TOWN PLANNING & DEVELOPMENT ADVICE

***MP 08-0003 Staged Construction of
32 Dwellings & Community Title Subdivision
1206D Pacific Highway, Moonee
Lot 211 DP 1044292 and Lot 1 DP 262300***

In respect all the issues raised in Councils letters I provide the following summary as a Preferred Project Report.

FIGURE 8

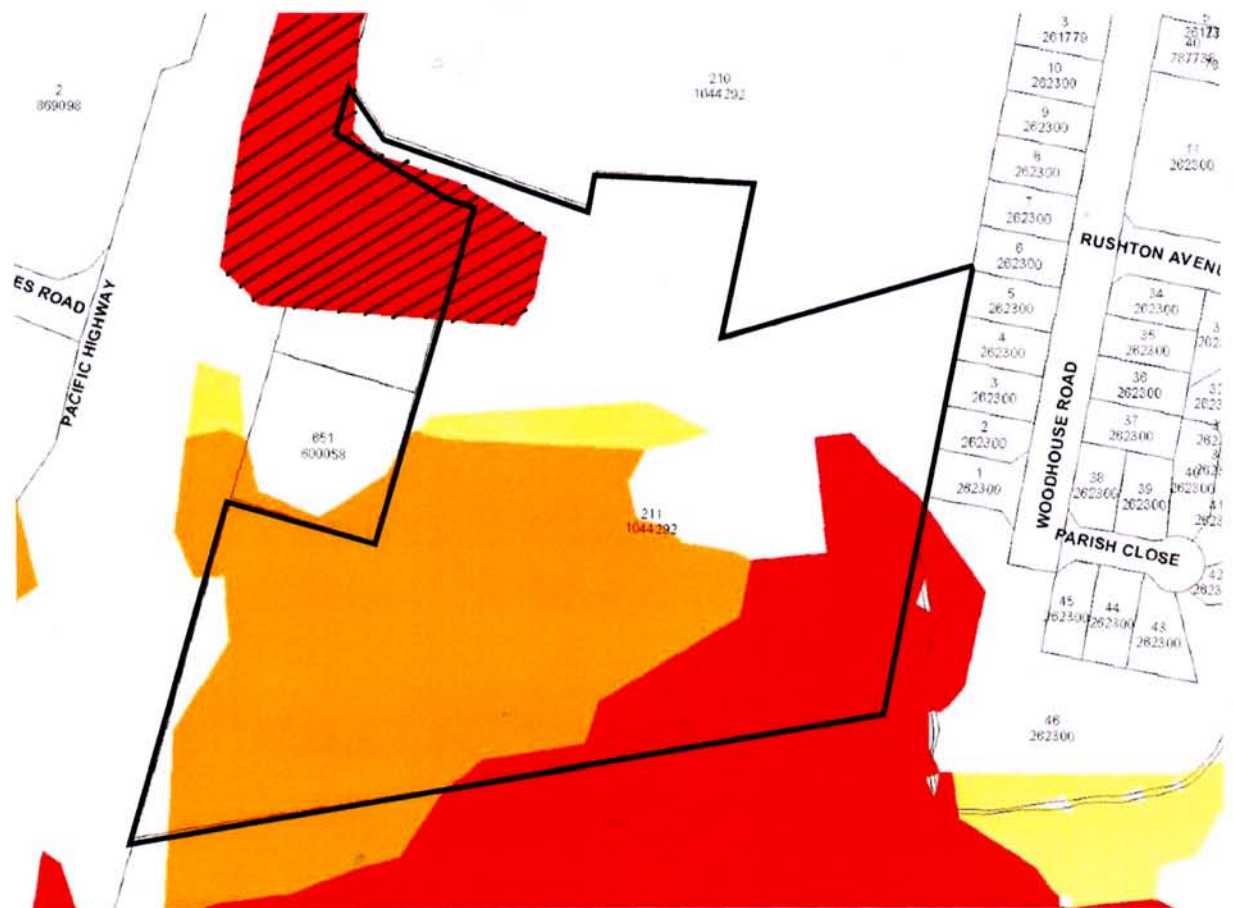
- Figure 8 – Ecological Status of Vegetation has been amended to distinguish between ‘Very High’ and ‘Low’ ecological value. A copy of the amended plan is enclosed as Attachment 1.
